FINDING OF NO SIGNIFICANT IMPACT
and
ENVIRONMENTAL ASSESSMENT
for the
Big Hole River Diversion Dam
in
Silver Bow and Beaverhead Counties, Montana

FINDING OF NO SIGNIFICANT IMPACT
for
Big Hole River Diversion Dam
in
Silver Bow and Beaverhead Counties, Montana

Appendix A:	NEPA/MEPA Coordination Process
Appendix B:	Edits/Corrections to the EA
Appendix C:	Comments and Responses
Appendix D:	Agency Correspondence Received After Close of Comment Period
Appendix E:	Environmental Assessment

Location	Action	Edit
Page 41, Figure 3-5	Replace existing figure with revised figure	See revised Figure 3-5 below.

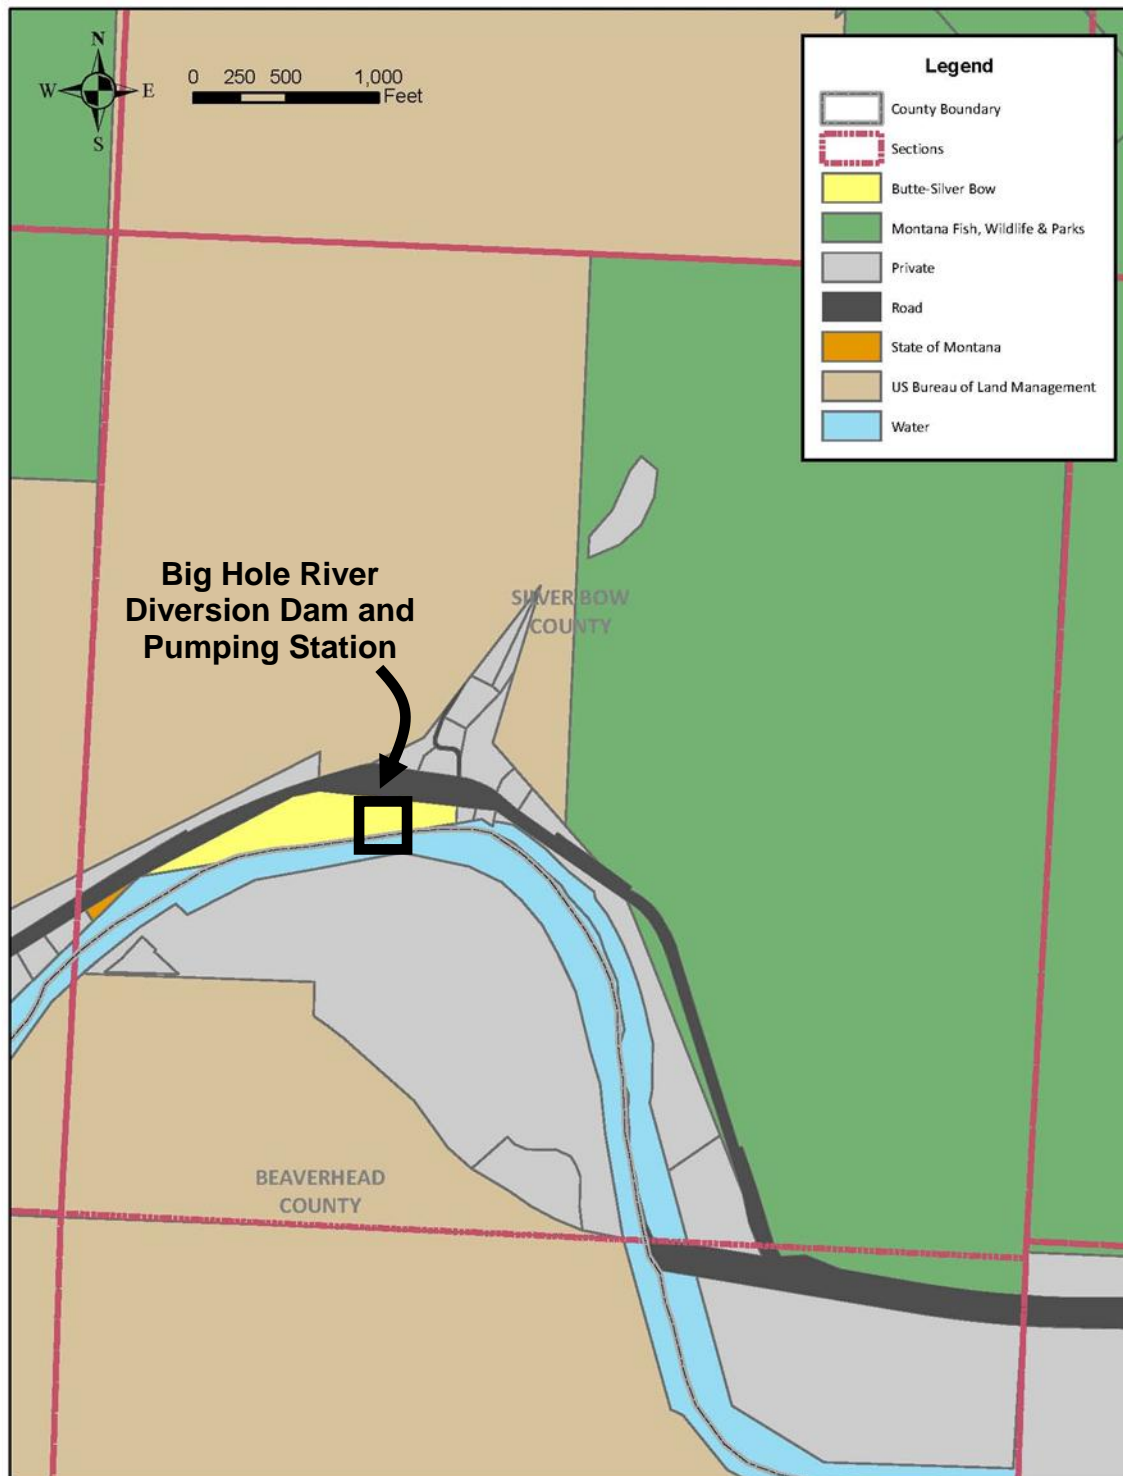
1-Page 41 of EA has a property ownership map and at the December public meeting I asked how accurate it was? The response I got from DOWL HKM was that they did not know. The EA needs to have a very accurate ownership map of the area so everyone knows what property might be affected by this project private or public.

- 1) The Land Ownership figure has been updated; please refer to Appendix B of the FONSI.

The plan for Alternative 3 is shown in the figure which follows.

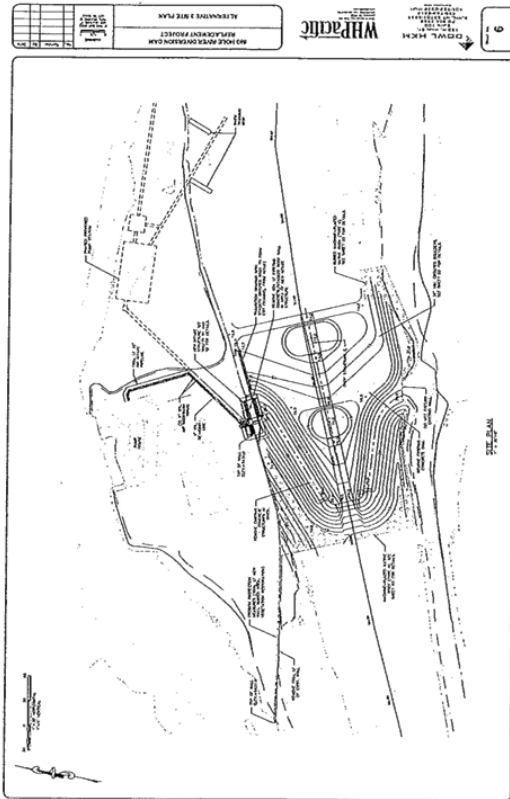
The site plan for Alternative 3 identifies a proposal to remove 150' of an existing retaining wall upstream of the diversion and to replace it with a new wall. HAER documentation of the existing wall, done consistent with other such documentation detailed above, must be completed in advance of the removal of this feature. Also, a detailed design for the new wall must be submitted to the HPC for review prior to construction. Any new wall should be constructed of materials compatible with the existing wall. Any new wall must be compatible with the *Secretary of the Interior's Standards for the Treatment of Historic Properties*.¹¹

Figure 3 of Appendix G of the draft EA (c. 1920) shows a variety of buildings and structures on the historic property.

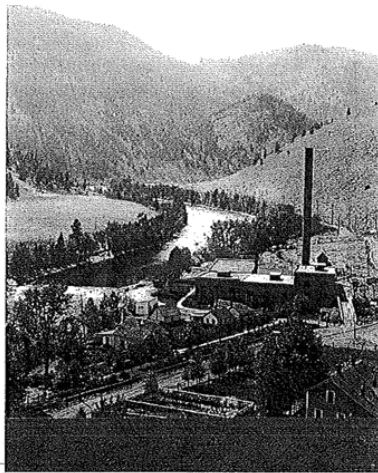
The draft EA is deficient as regards inventory, assessment and plans regarding archaeological resources. Section 4.1 of Appendix G states the following (emphasis added).

Most of these buildings or structures are no longer extant. However, the EA does not account for the possibility that archaeological remains of these buildings and structures
